**Re: Petition 1347A - GRE GACRUX LLC Petition for a Declaratory Ruling, Pursuant to Connecticut General Statutes §4-176 and §16-50k, for the Proposed Construction, Maintenance and Operation of a 16.78 MW AC Solar Photovoltaic Electric Generating Facility Located at 117 Oil Mill Road and Associated Electrical Interconnection to Eversource Energy's Existing Substation at 325 Waterford Parkway North in Waterford, Connecticut. Reopening of this Petition Based on Changed Conditions Pursuant to Connecticut General Statutes §4-181a(b).**

**Petition No. 1347A**

**GRE GACRUX LLC'S RESPONSES TO THE CONNECTICUT  
SITING COUNCIL'S FIRST SET OF INTERROGATORIES**

# PHOTOVOLTAIC ONE-LINE POWER RISER DIAGRAM

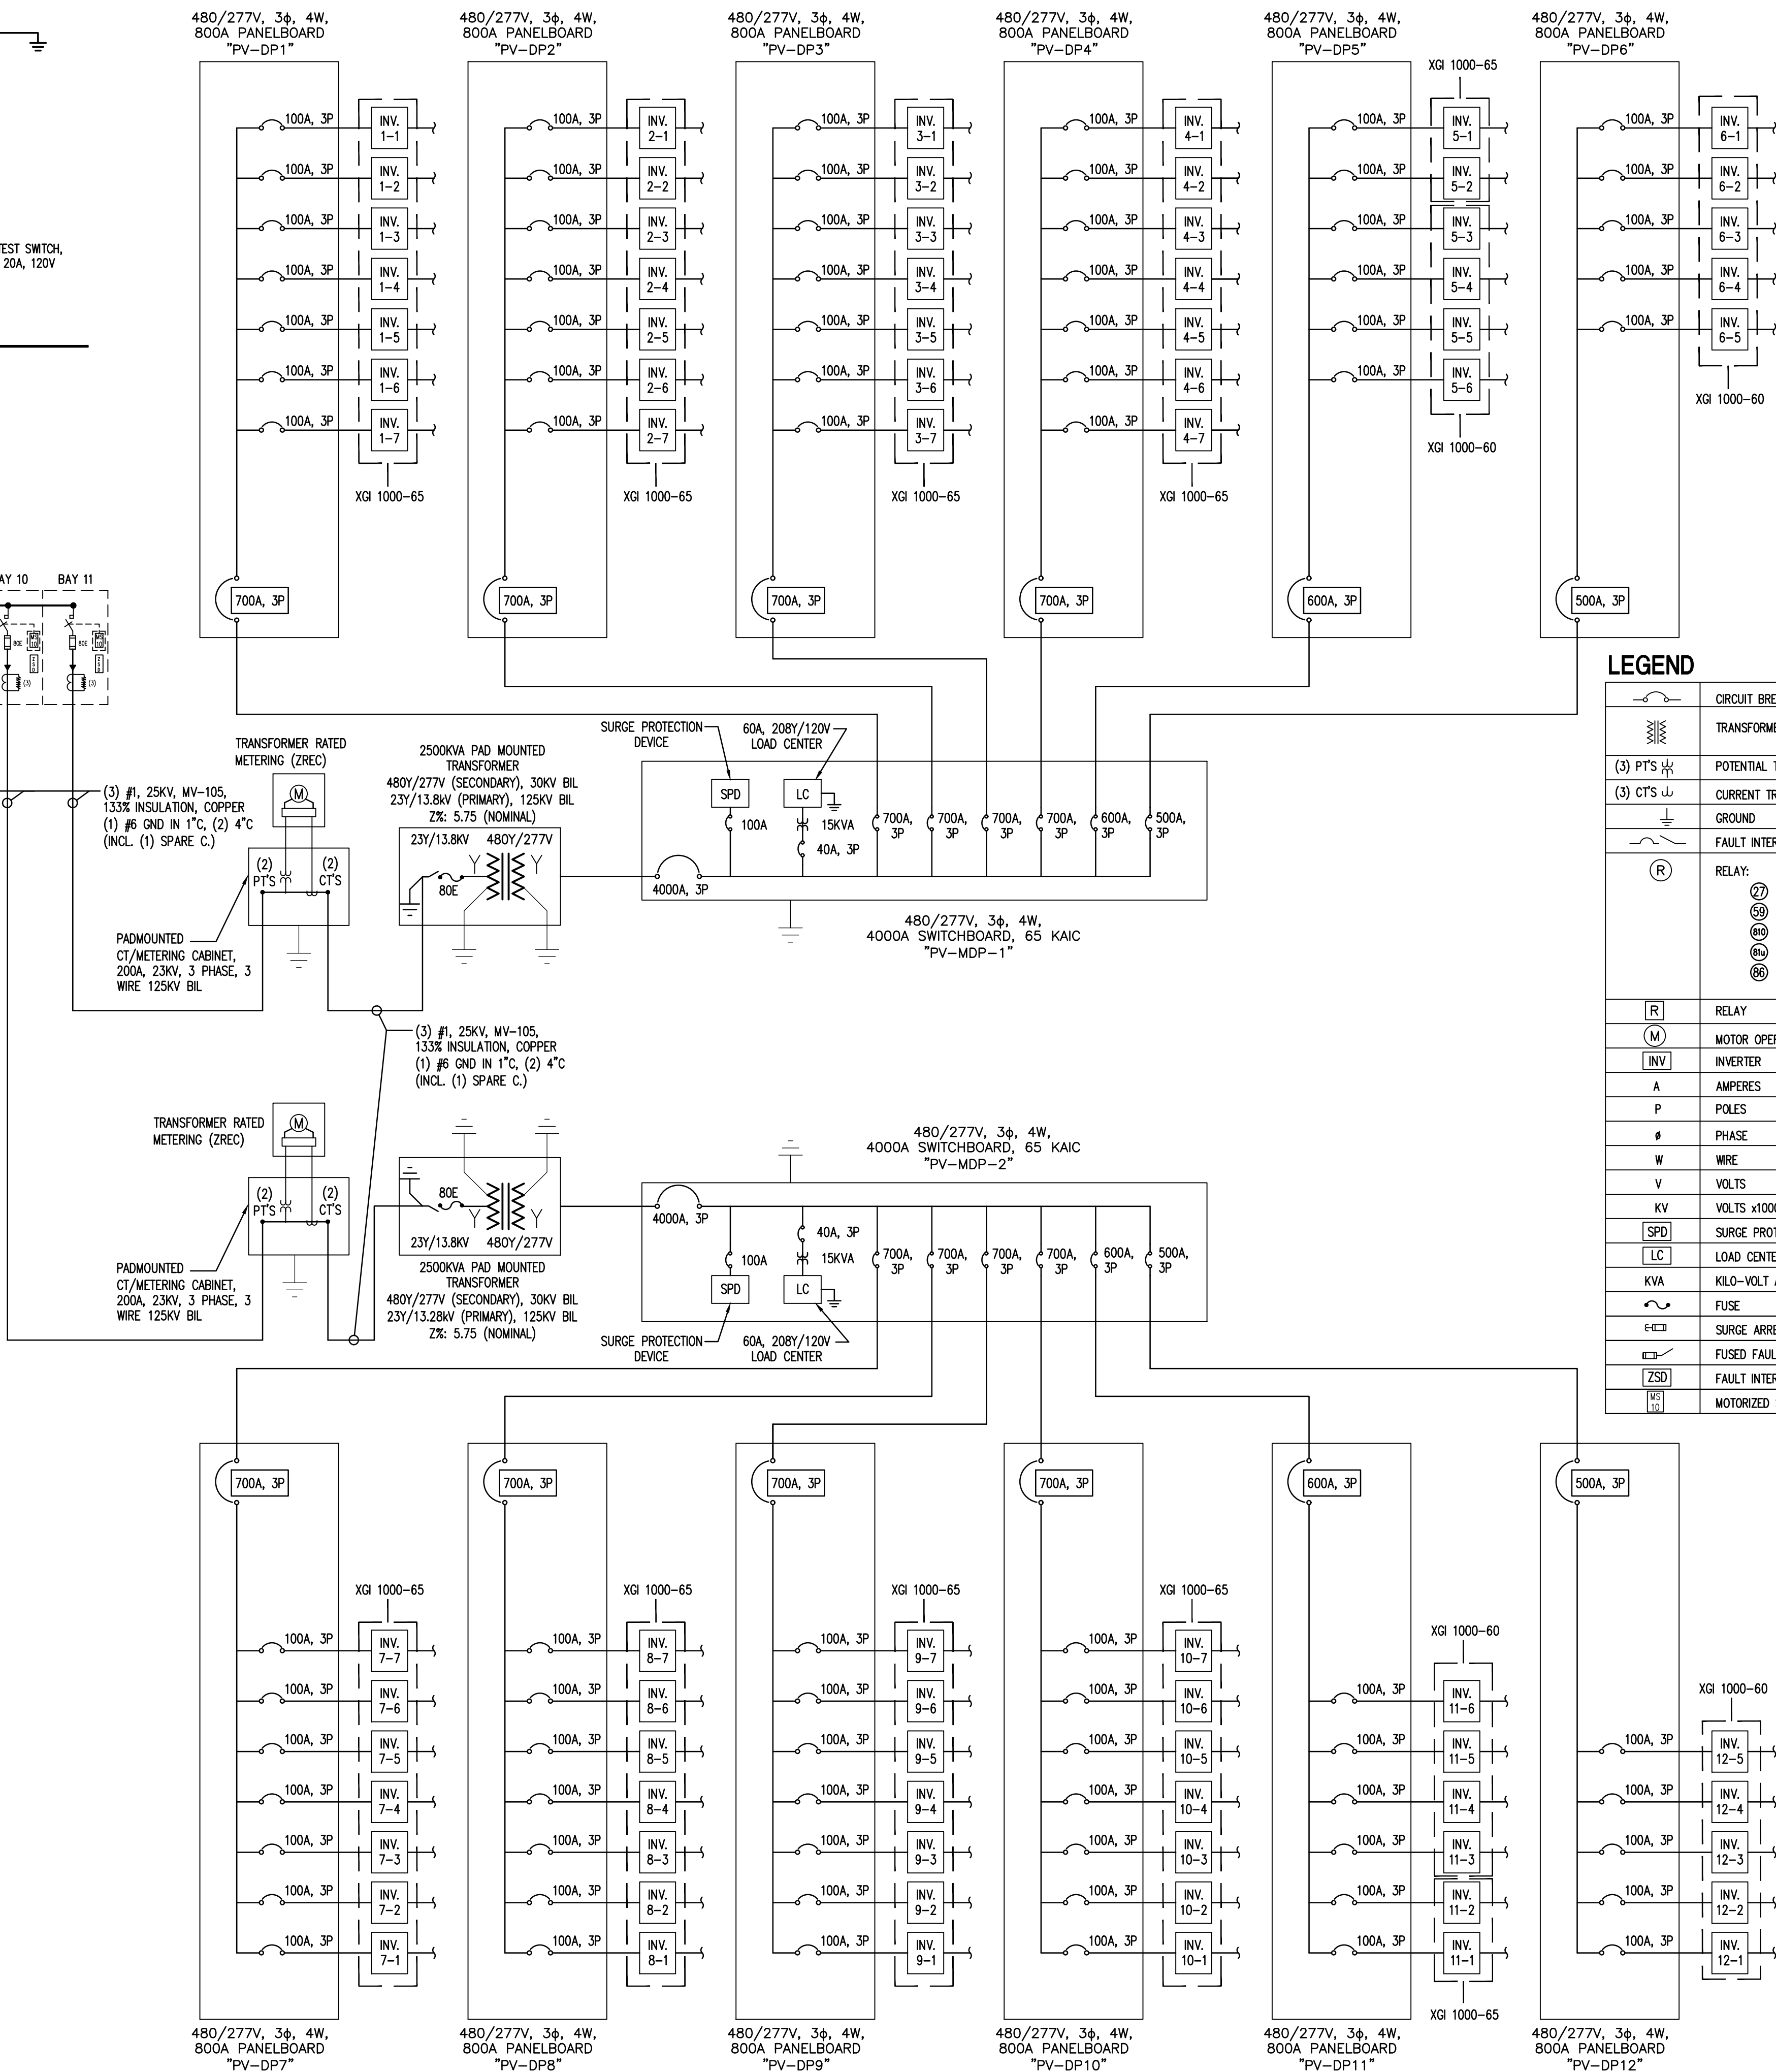
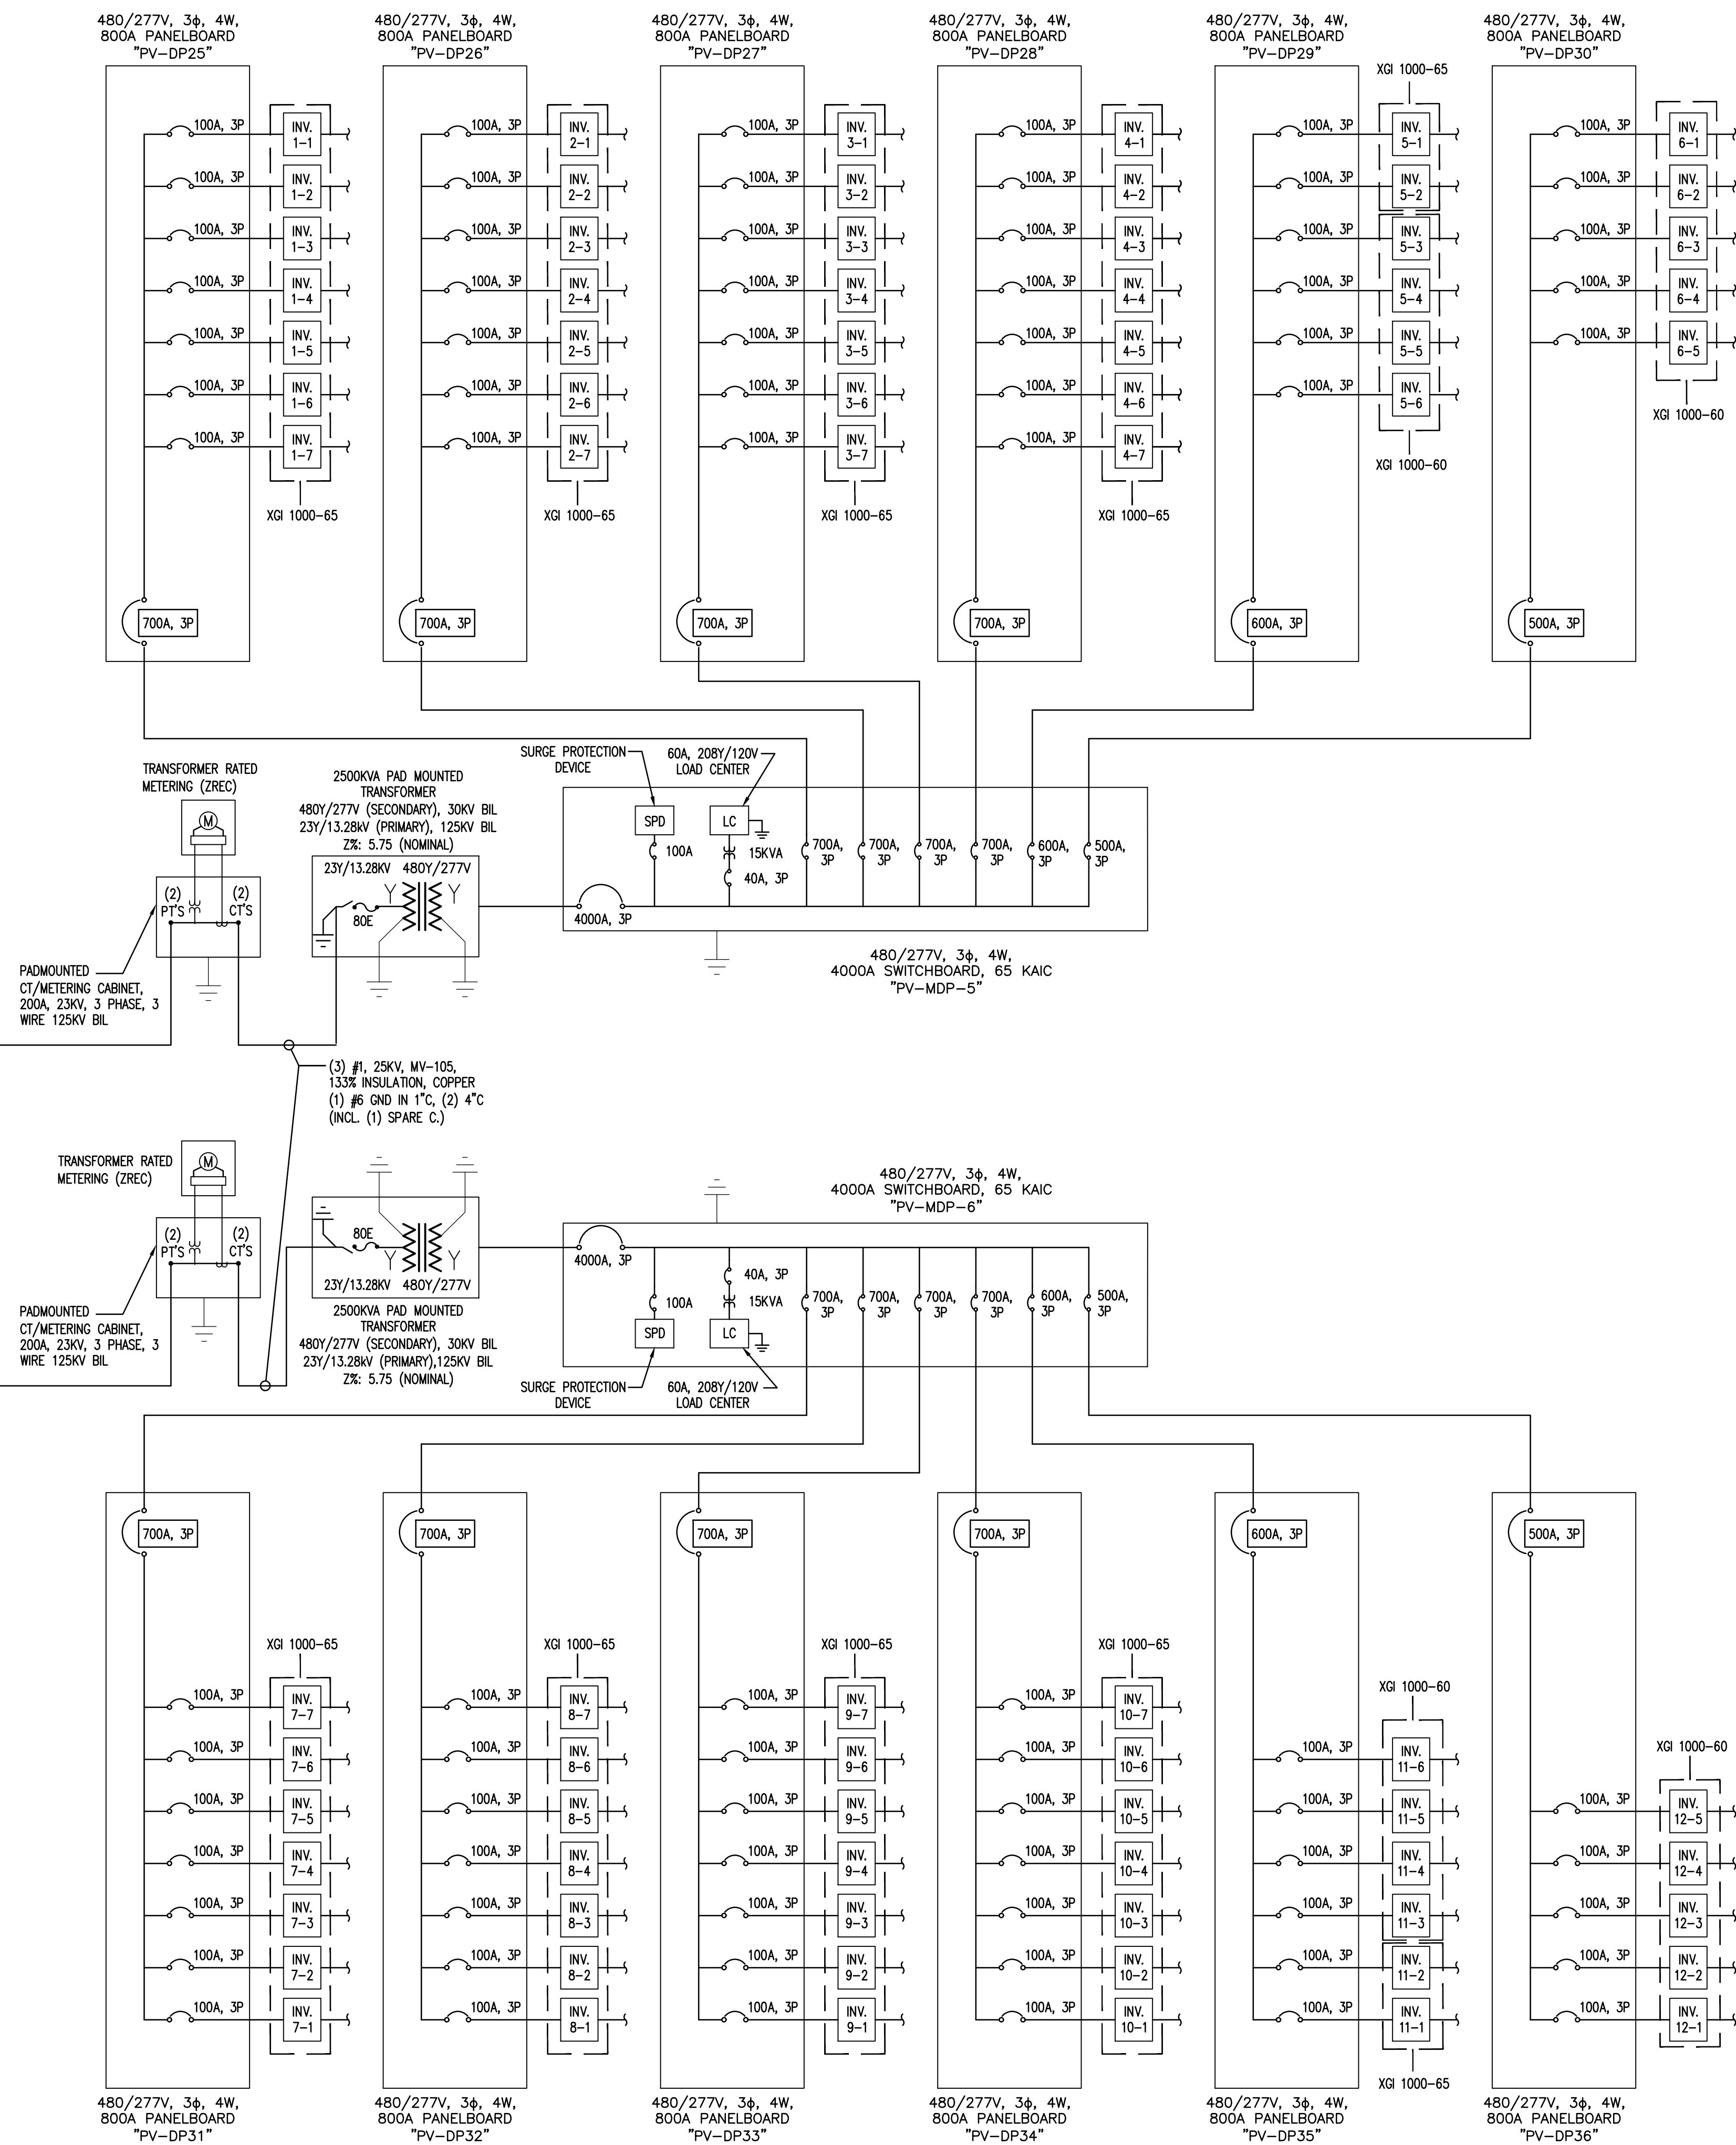
29. The hard copy version of the Petition Appendix A contains a PV Site Plan series that was not submitted in .pdf format. Provide a .pdf version of the PV Plan series.

A .pdf version of the PV Plan series is included herein as Exhibit F.
